**BEFORE THE BOARD OF PATENT APPEALS
AND INTERFERENCES**

Application Number: 10/777,366
Filing Date: February 12, 2004
Appellant(s): GIRARD ET AL.

EXAMINER'S ANSWER

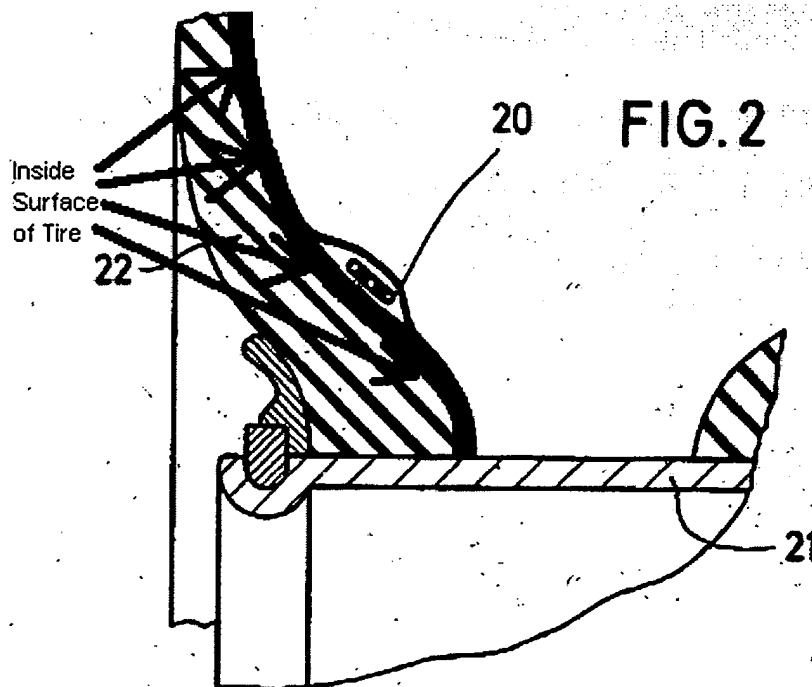
Fritze discloses a tire (22 in Figure 2) and an antenna assembly vulcanized to the inside of the tire, the antenna assembly projecting from the inside surface to face the tire inner cavity - note especially Figure 2 and col. 3, lines 59-66. In particular, in

describing the location of the antenna assembly in Figure 2, Fritze expressly describes that the "oscillator-antenna unit is vulcanized to the *inside* of the tire in proximity to the radial rim outer edge" (col. 3, lines 62-64; emphasis added). Since described as vulcanized to the inside of the tire, the assembly is bonded during a cure (i.e. vulcanization) cycle. The antenna assembly also is clearly depicted to project from the inner surface of the tire to face the inner cavity of the tire (Figure 2). The structural features of the tire implied by the steps of claim 9 are therefore considered to be clearly met by Fritze.

The following marked up copy of Figure 2 of Fritze was previously provided by the examiner responsive to arguments by Appellants and is included here to further emphasize what is the antenna assembly and what is the inner surface of the tire (i.e. the tire is the *cross-hatched part 22* and the inner surface thereof is thus as indicated).

Thus, the added highlighted black line represents the inside surface of the tire while the entire protruding assembly inward thereof (including strands 20 as well as surrounding material) represents the antenna *assembly* (in the same way that appellants antenna assembly includes the wires 32 *encapsulated* within strip 36 - see paragraph [0011] on page 4 of appellants specification). Again, the claims do not define or imply any tire structure that would distinguish this.

From the depiction in Figure 2 read with the description that the "oscillator-antenna unit is vulcanized to the inside of the tire in proximity to the radial rim outer edge" (col. 3, lines 62-64), it is however submitted that the tire clearly meets each of these requirements. The tire (22) is depicted by cross-hatching in Figure 2, the entire protruding assembly inward from the tire (including the strands 20 as well as the surrounding supporting material) representing the *antenna assembly*. Note again the marked up copy of Figure 2 in the statement of rejection. The outward surface of this assembly is vulcanized (i.e. bonded during a cure cycle) to the inner surface of the tire and the inward surface of this assembly is unbonded to the tire and faces an inner cavity of the tire.

representing the *antenna assembly* (in the same way that appellants antenna assembly includes the wires 32 encapsulated within strip 36 - see paragraph [0011] on page 4 of appellants specification). Note again the marked up copy of Figure 2 in the statement of rejection. The outward surface of this assembly is vulcanized (i.e. bonded during a cure cycle) to the inner surface of the tire and the inward surface of this assembly is unbonded to the tire and faces an inner cavity of the tire.

Note again the marked up copy of Figure 2 in the statement of rejection. The outward surface of this assembly is vulcanized (i.e. bonded during a cure cycle) to the inner surface of the tire and the inward surface of this assembly is unbonded to the tire and faces an inner cavity of the tire.
